Re: Stripes on Wyoming
2505 Wyoming Blvd NW
Traffic Circulation Layout
Engineer's/Architect's Stamp 12-2-19 (H19D049)

Based upon the information provided in your submittal received 12-3-19, the above referenced plan cannot be approved for Building Permit until the following comments are addressed:

2
TCL
REMODELED SITE PLAN

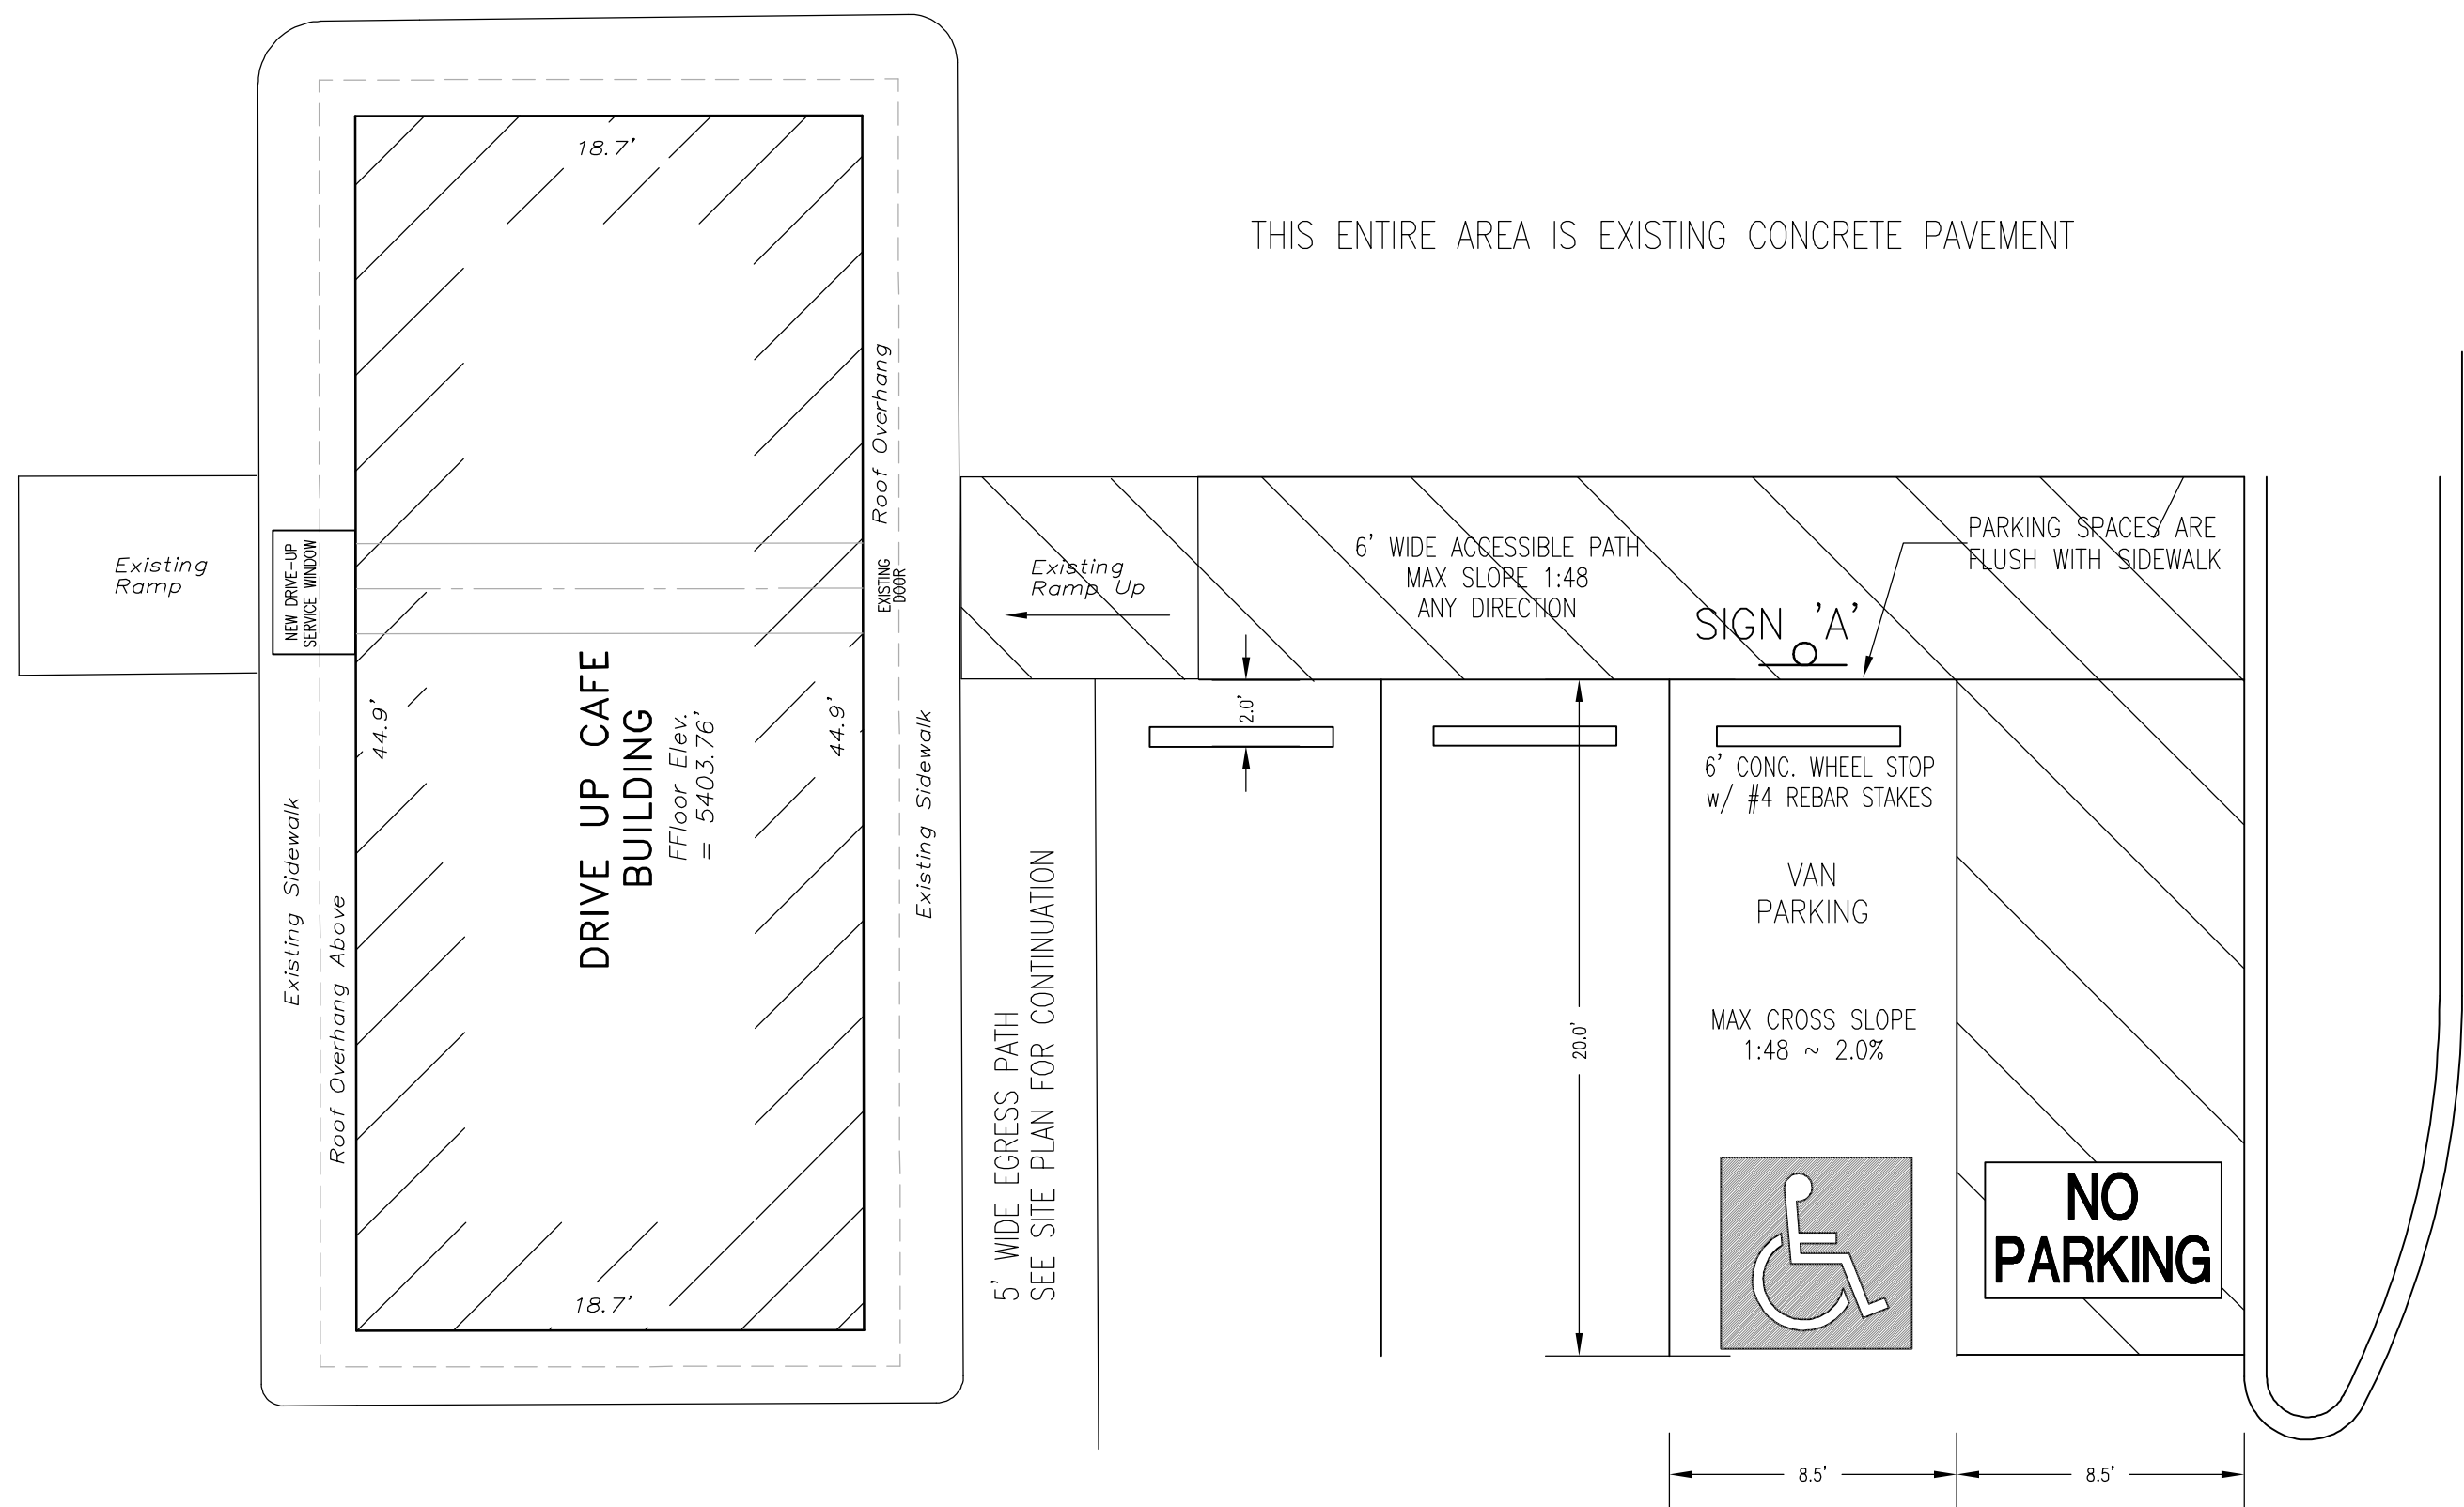
1. Per the IDO, a 6 ft. wide ADA accessible pedestrian pathway is required from the public sidewalk to the building entrances. Please clearly show this pathway and provide details. (Path provided indicates 5')

4. Remove raised concrete curb on top of side walk (Access of Wyoming) (Add detail if modifying the drive apron and sidewalk)
5. Service vehicle and/or refuse vehicle maneuvering must be contained on-site; provide a copy of refuse approval.

6. Please remove existing ramp at service window.
7. Please correct signage for motorcycle parking. (Plan indicates Sign A, ADA parking)
8. One-way vehicular paths require pavement directional signage and a posted "**Do Not Enter**" sign at the point of egress. Please show detail and location of posted signs. (Please add Do Not Enter at exit only access off Claremont Ave) (Please add signs and floor markings at drive through exit.)

9. Please provide a sight distance exhibit.
10. Show the clear sight triangle and add the following note to the plan:
"Landscaping and signage will not interfere with clear sight requirements. Therefore, signs, walls, trees, and shrubbery between 3 and 8 feet tall (as measured from the gutter pan) will not be acceptable in the clear sight triangle."

6 ACCESSIBLE PARKING AREA
TCL

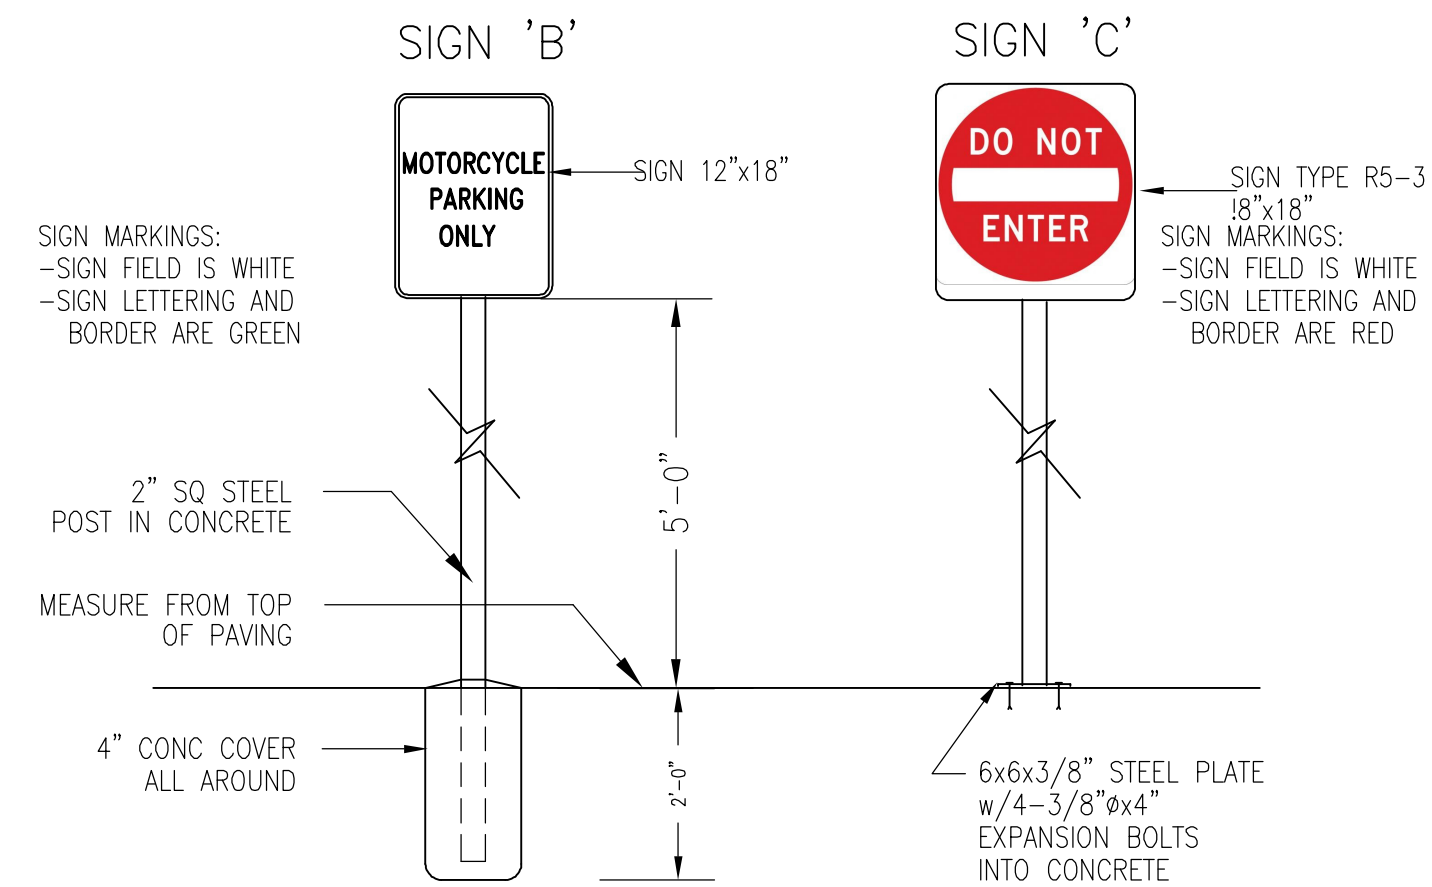
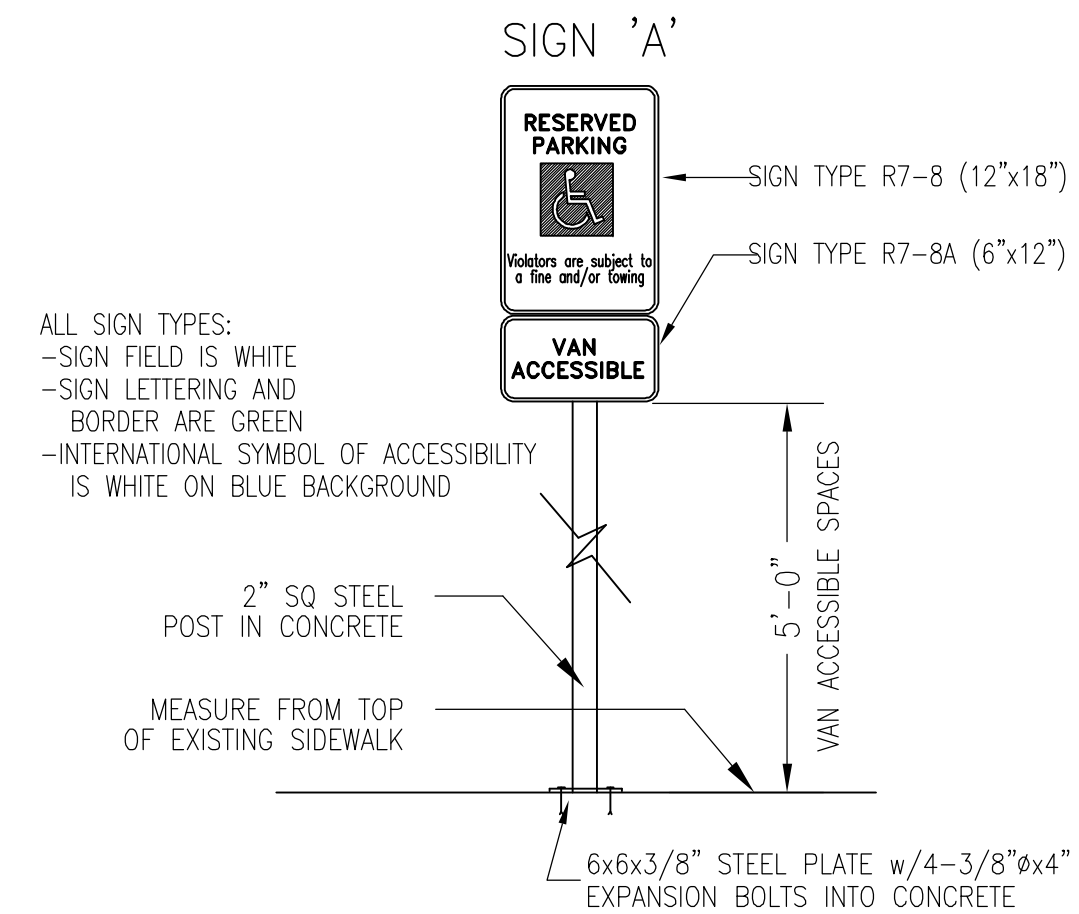
2. Please indicate running and cross slopes on existing ramp. (8.0 % max running slope / 2.0% max cross slope. (Please update to ADA compliance)
3. Please correct Detail 6/TCL ACCESSIBLE PARKING AREA to match TCL site plan. (Parking Clacs may need adjustment after correction.)
